## V2 - Response to the V1 Comments

**RE: Broadmoor  
CID, 1<sup>st</sup> Review  
Town of Rolesville Project No. CID-24-06  
WR Project No. 23-0045**

#### SL1.00 – Lighting Plan

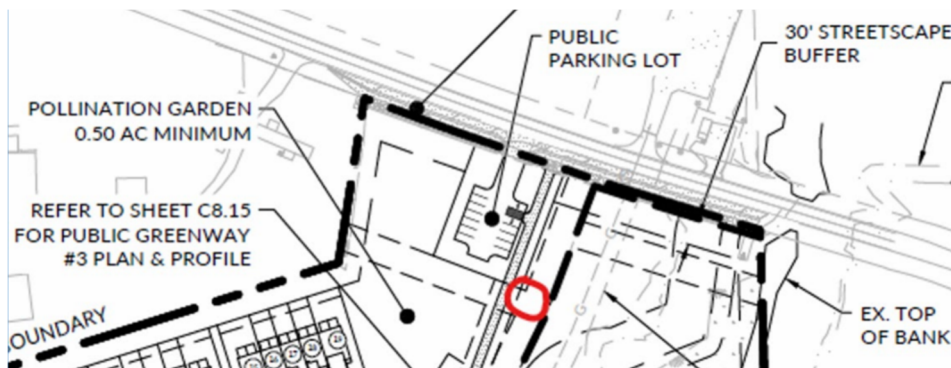
12. This says that 81 poles are to be installed;
  - a. Provide a table that breaks down the number of Street light poles in public right-of-ways, by Phase. This will be required to determine the one time \$650/pole fee at time of Final Plat submittal / review. Poles in private parking lots should be noted as such (they can still be counted, so that all [81] poles in the subdivision are counted and reflected, but the important aspects is those in public ROW). It would be great if the poles were numbered to assist with this. Also:
  - b. LDO 6.6.G.13 – “Light fixtures shall not exceed thirty (30) feet in height in vehicle use areas (such as rights-of-way and parking areas).” – SL1.00 indicates maximum height to be 35' – revise to comply.
  - ▶ **Lighting table has been revised to break out ROW vs Parking lights by phase. Light poles have been revised to 30' height**

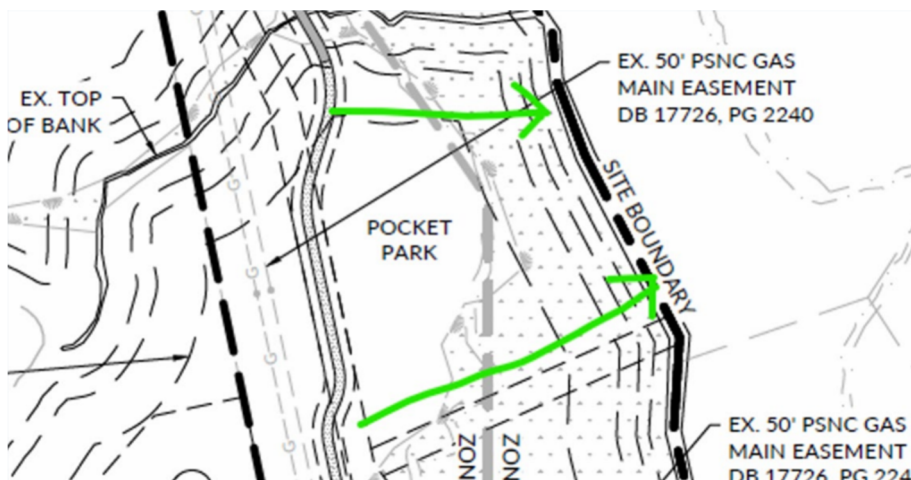
14. Revise to show 10' by 10' Outdoor Museum Station near public parking lot off of Fowler Road; see clip below. Staff and Planning Board members have discussed this in the past about this monument at this location.

▶ **A 10' by 10' Outdoor Museum Station has been added next to the greenway and labeled on sheet C3.07.**
